1. Legal Ad

3. 185 Fore Street

3.I. Memo

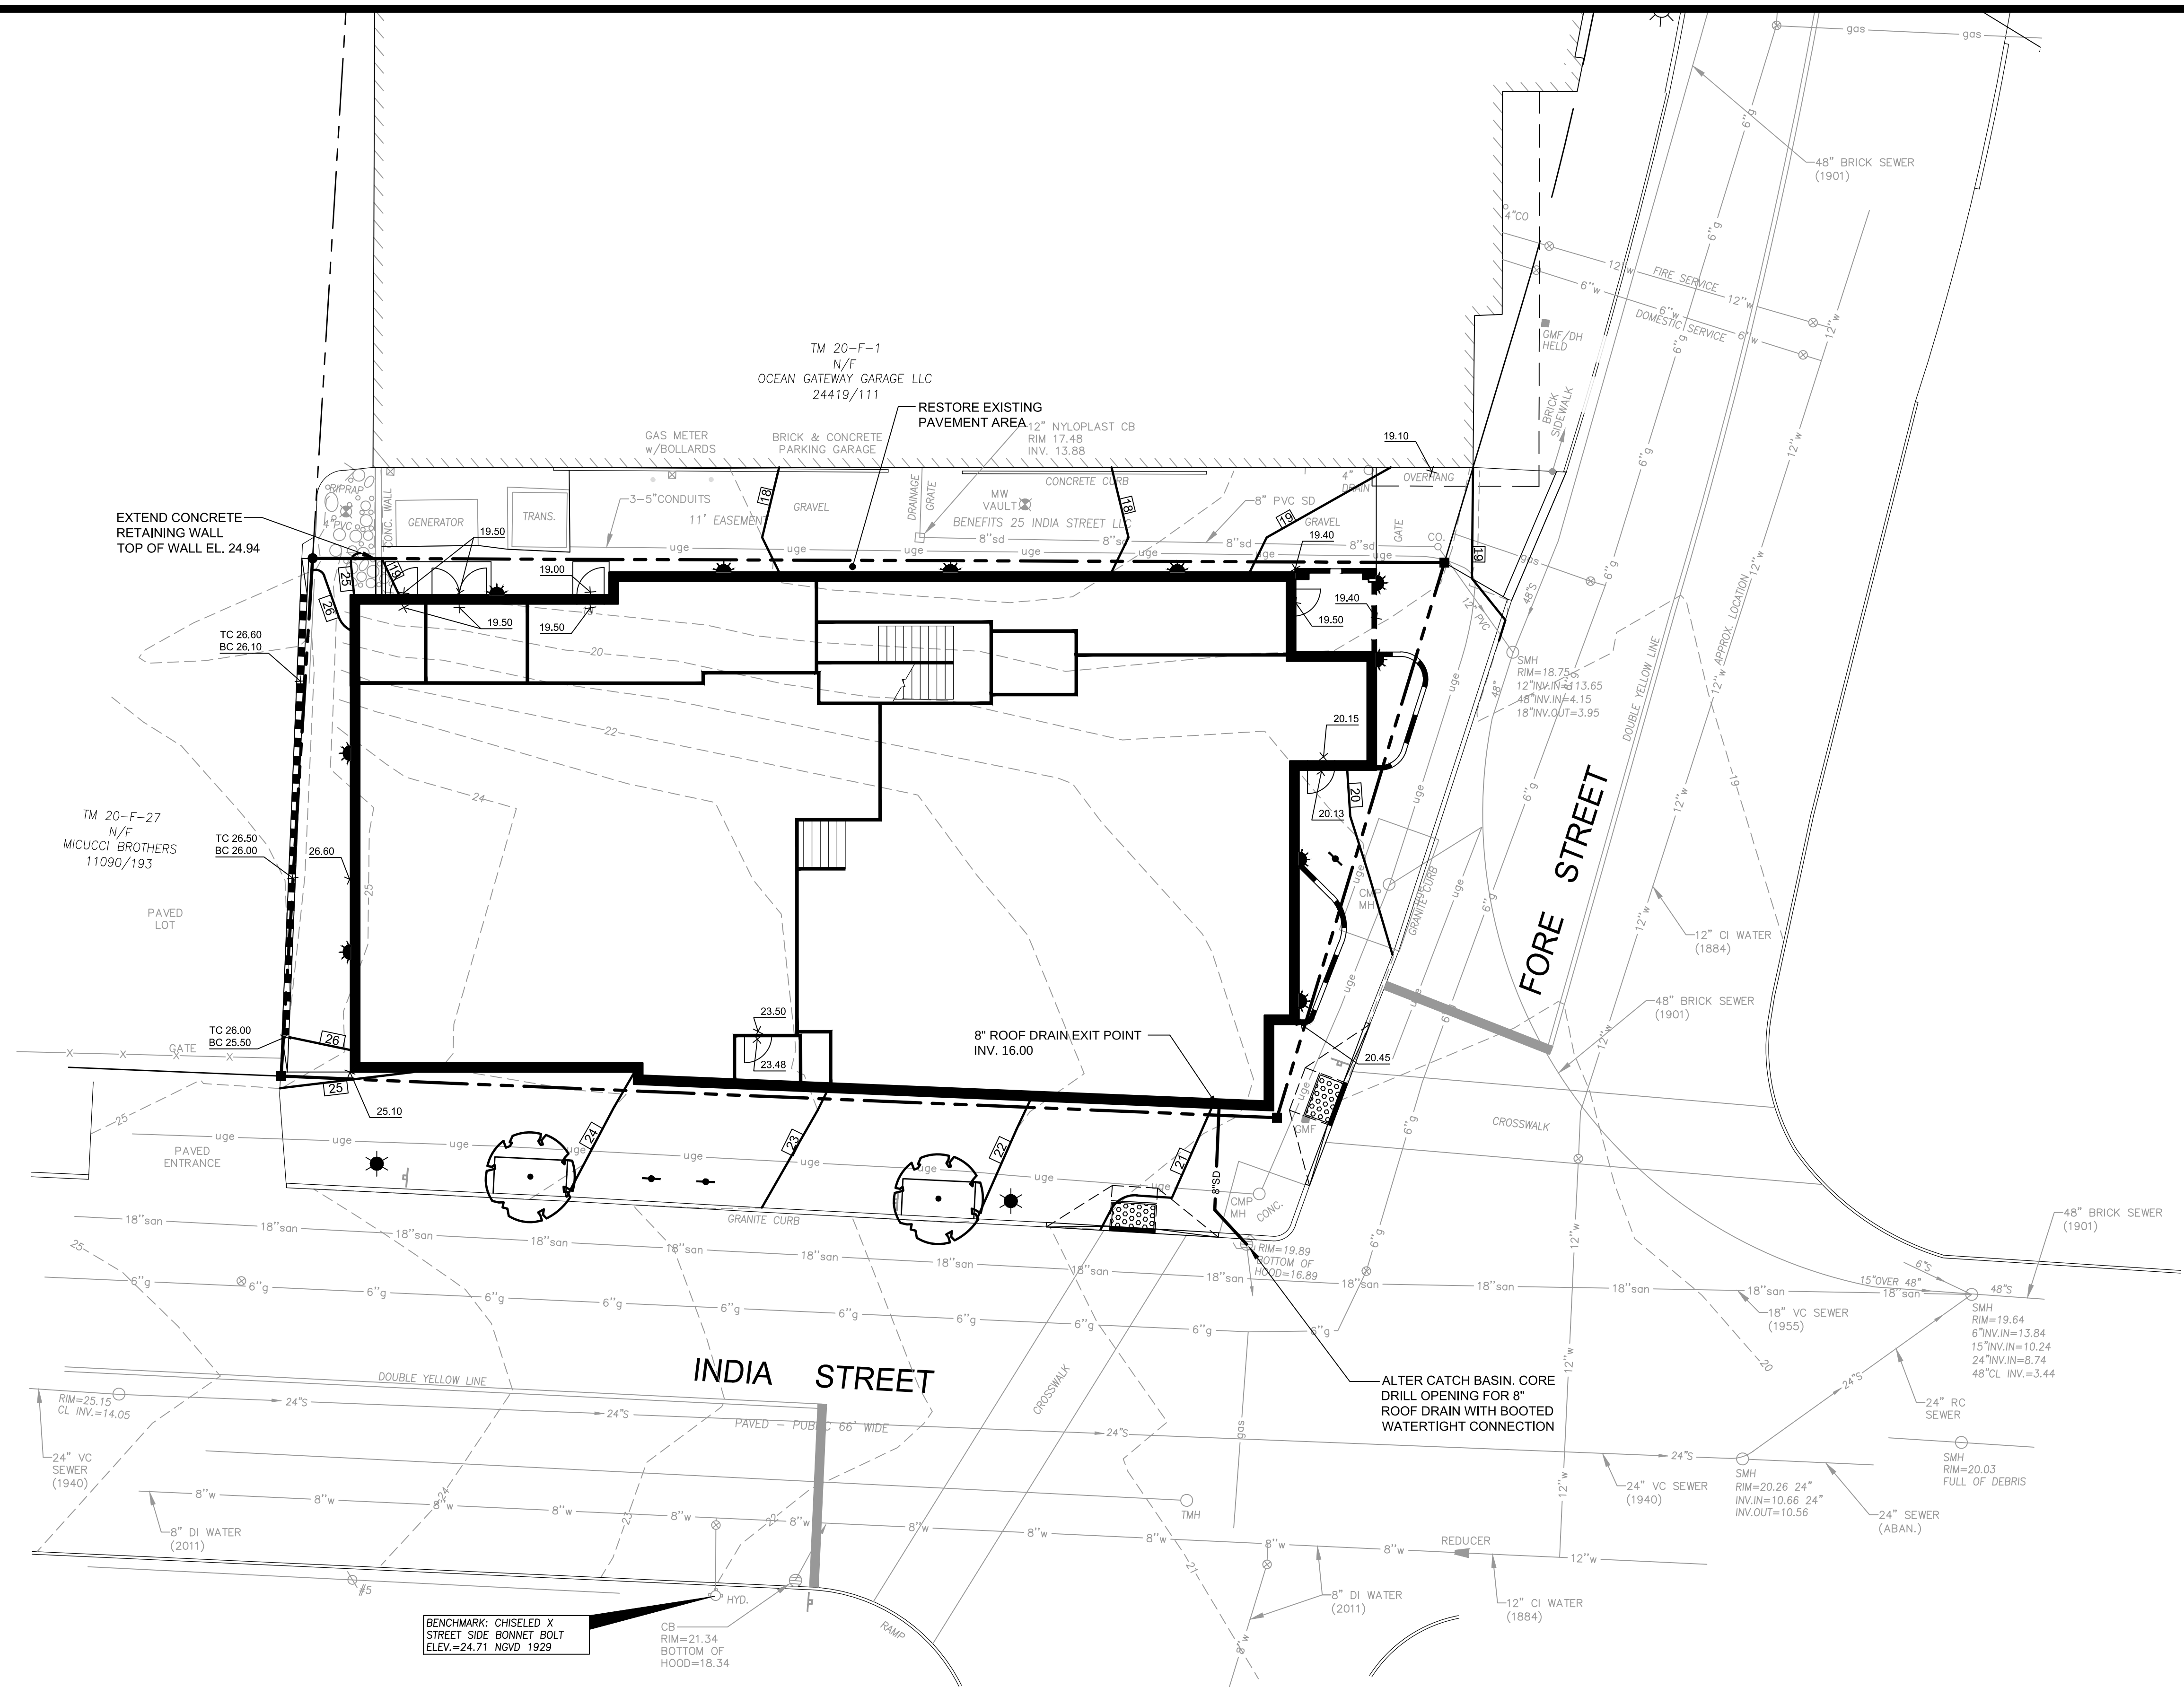
- 9) Sheet C-3.0 indicates to "Restore Ex. Bituminous Pavement Area" in the alley between the proposed building and the Ocean Gateway Garage; however, the Boundary & Topographic Survey indicates that this area is gravel. The Applicant will be required to pave this alleyway as part of this project.

Sheet C-3.0 indicates to “Restore Ex. Bituminous Pavement Area” in the alley between the proposed building and the Ocean Gateway Garage; however, the Boundary & Topographic Survey indicates that this area is gravel. The Applicant will be required to pave this alleyway as part of this project.
